# UNITED STATES PATENT AND TRADEMARK OFFICE

10/620,575

**Office Action Summary**

## **DETAILED ACTION**

**FIG. 3**

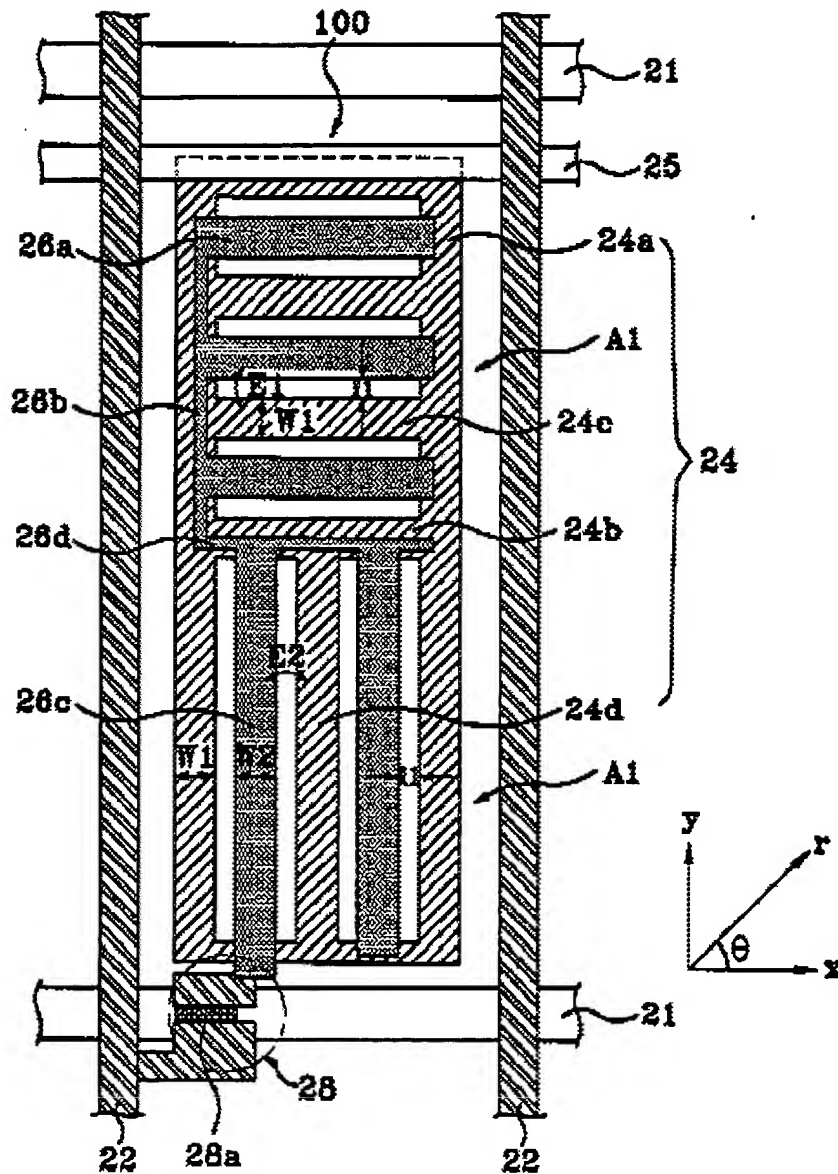
As to claim 18, Lee discloses (Abstract, Title, entire patent and first embodiment) an array substrate for an IPS-LCD device (col. 6, line 35 through col. 9, line 54), comprising:

a substrate; a gate line, 21, on the substrate; a data line, 22, perpendicular to the gate line; a thin film transistor, 28, at a crossing portion between the gate and data lines; a common line, 25, parallel to the gate line; a plurality of common electrodes, 24d, 24a,

and its counterpart on the left, extending perpendicular to the common line, the plurality of common electrodes being divided into first and second portions of respective first and second domains [multiple common electrode portions in upper and lower domains]; a plurality of pixel electrodes, 26c and 26b, arranged alternately with the plurality of common electrodes, the plurality of pixel electrodes being divided into first and second portions of the respective first and second domains [multiple pixel electrode portions in upper and lower domains]; an auxiliary common electrode, 24c, perpendicularly contacting each of the common electrodes; and an auxiliary pixel electrode, 26d, perpendicularly contacting each of the pixel electrodes; wherein the auxiliary pixel electrode is spaced apart from the auxiliary common electrode; and the pixel electrodes are on a same layer as said auxiliary pixel electrode.

As to claim 19, Lee discloses (Abstract, Title, entire patent and first embodiment) an array substrate for an IPS-LCD device (col. 6, line 35 through col. 9, line 54), comprising: a substrate; a gate line, 21, on the substrate; a data line, 22, perpendicular to the gate line; a thin film transistor, 28, at a crossing portion between the gate and data lines; a common line, 25, parallel to the gate line, the common line including first and second auxiliary common lines, 24d, 24a, and its counterpart on left, perpendicular to the common line; a plurality of common electrodes, 24b and 24c, extending perpendicular to the first and second auxiliary common lines, the plurality of common electrodes being divided into first and second portions of respective first and second domains [multiple common electrode portions in upper and lower domains]; a plurality of

pixel electrodes, 26a and its counterparts, arranged alternately with the plurality of common electrodes, the plurality of pixel electrodes being divided into first and second portions of the respective first and second domains [multiple pixel electrode portions in upper and lower domains]; an auxiliary common electrode, 24a (dual purpose), perpendicularly contacting each of the common electrodes; and an auxiliary pixel electrode, 26b, perpendicularly contacting each of the pixel electrodes, wherein the auxiliary pixel electrode is spaced apart from the auxiliary common electrode.

Please note that Applicant's "being divided into first and second portions of the respective first and second domains" is not explicitly defined in the specification, and the description of Applicant's "being divided into first and second portions of the respective first and second domains" and the broad interpretation of same are considered met by the structure of Lee.

As to claim 20, Lee discloses (Abstract, Title, entire patent and first embodiment) an array substrate for an IPS-LCD device (col. 6, line 35 through col. 9, line 54), comprising: a substrate; a gate line, 21, on the substrate; a data line, 22, perpendicular to the gate line; a thin film transistor, 28, at a crossing portion between the gate and data lines; a common line, 25, parallel to the gate line, the common line including a plurality of common electrodes, 24d, 24a, and its counterpart on the left, extending perpendicular to the common line; a plurality of pixel electrodes, 26c and its counterpart on the right, arranged alternately with the plurality of common electrodes; and a plurality

of auxiliary electrodes, 24b, 24c, and 26d, connecting the plurality of common and pixel electrodes to form a multi-domain having a check pattern.

Please note that Applicant's "check pattern" is not explicitly defined in the specification, and the description of Applicant's "check pattern" and the broad interpretation of same are considered met by the structure of Lee.

**FIG. 10**

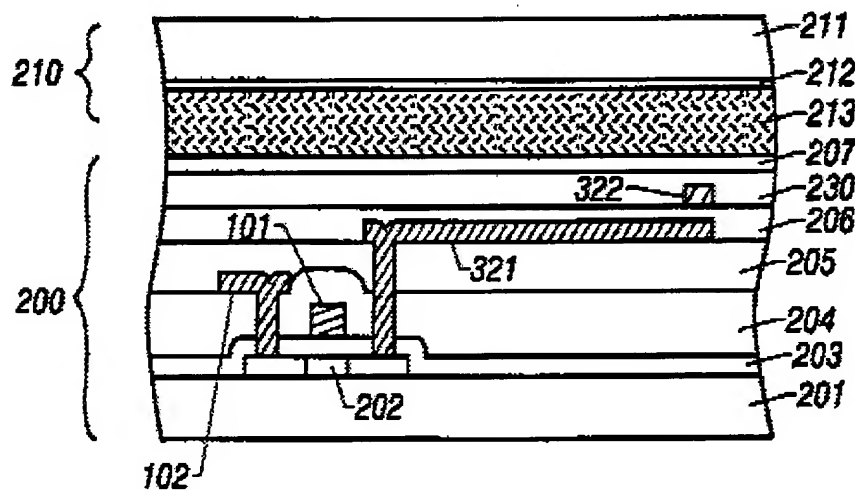
Hirakata teaches in the fourth embodiment (col. 8, line 56 through col. 9, line 34) a dielectric film, 205 (Applicant's first passivation layer), over the gate insulating layer, the data line and thin film transistor; a plurality of pixel electrodes, 321, on the first passivation layer; a second dielectric film, 206 (Applicant's second passivation layer), over the pixel electrodes; a common line, 322, on the second passivation layer to comprise a structure with increased aperture ratio (col. 8, lines 57-59).

Hirakata is evidence that ordinary workers in the art of liquid crystals would find the reason, suggestion, or motivation to add a first passivation layer over the gate insulating layer, the data line and thin film transistor; a plurality of pixel electrodes on the first passivation layer; a second passivation layer over the pixel electrodes; a common

line on the second passivation layer to comprise a structure with increased aperture ratio.

Therefore, it would have been obvious to one having ordinary skill in the art of liquid crystals at the time the invention was made to modify the LCD of Lee with the first passivation layer over the gate insulating layer, the data line and thin film transistor; a plurality of pixel electrodes on the first passivation layer; a second passivation layer over the pixel electrodes; a common line on the second passivation layer of Hirakata to comprise a structure with increased aperture ratio.

**FIG. 7**

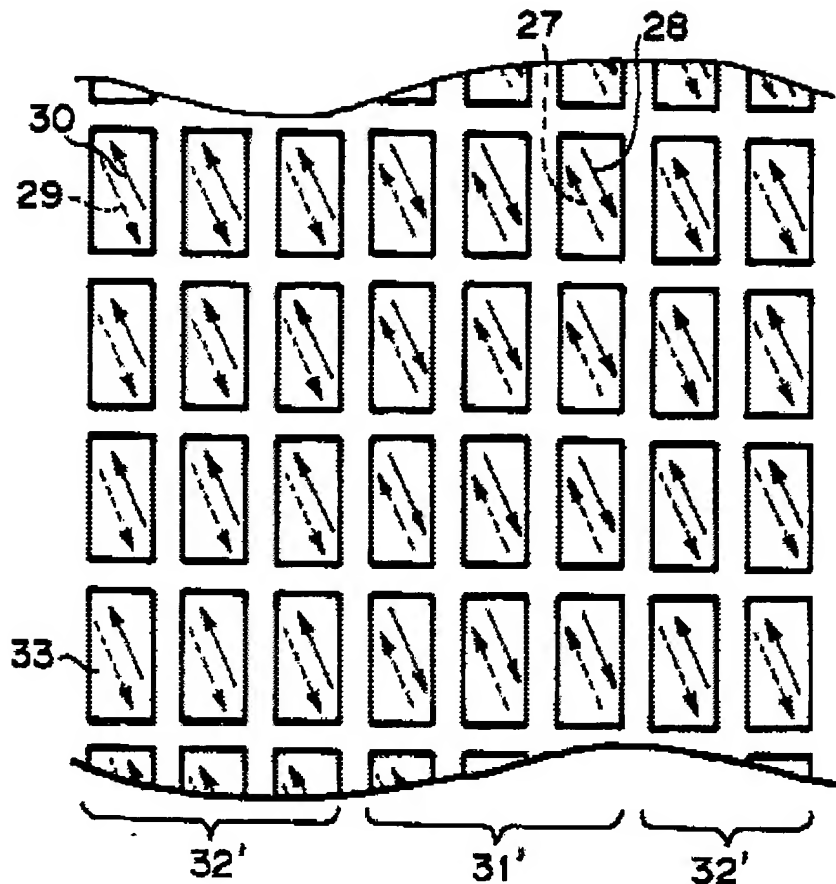
Okamoto teaches (Abstract, Title, entire patent) an alignment layer having first and second rubbing directions, the first and second rubbing directions corresponding to the first and second domains, respectively (col. 3, lines 25-59) to enhance image quality by preventing dependence on the viewing angle in the vertical and right-and-left directions.

Okamoto is evidence that ordinary workers in the art of liquid crystals would find the reason, suggestion, or motivation to add an alignment layer having first and second rubbing directions, the first and second rubbing directions corresponding to the first and second domains, respectively, to enhance image quality by preventing dependence on the viewing angle in the vertical and right-and-left directions.

Therefore, it would have been obvious to one having ordinary skill in the art of liquid crystals at the time the invention was made to modify the LCD of Lee with the

alignment layer having first and second rubbing directions, the first and second rubbing directions corresponding to the first and second domains, respectively of Okamoto to enhance image quality by preventing dependence on the viewing angle in the vertical and right-and-left directions.

Please note that rubbing directions are relative to other variables of design, including polarizer angles and retarder angles. Therefore, it would be well known to those having ordinary skill in the art of liquid crystals at the time the claimed invention was made to arrange the rubbing directions to be symmetrical about a line parallel to the gate line as a function of polarizer angles and retarder angles.

FIG. 5A

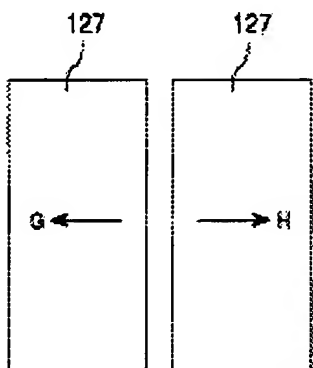
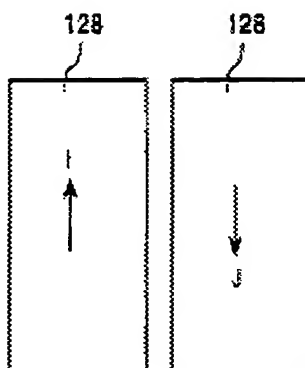
Chen teaches (Abstract, Title, entire patent, Figures 5A and 5B) an alignment layer having first and second rubbing directions, the first and second rubbing directions corresponding to the first and second domains, respectively to enhance image quality by preventing dependence on the viewing angle in the vertical and right-and-left directions with a process as simple as possible [abstract].

Please note that one of the two illustrated arrangements of Chen would be symmetrical about a line parallel to the gate line regardless of whether the gate line runs up and down, or left and right.
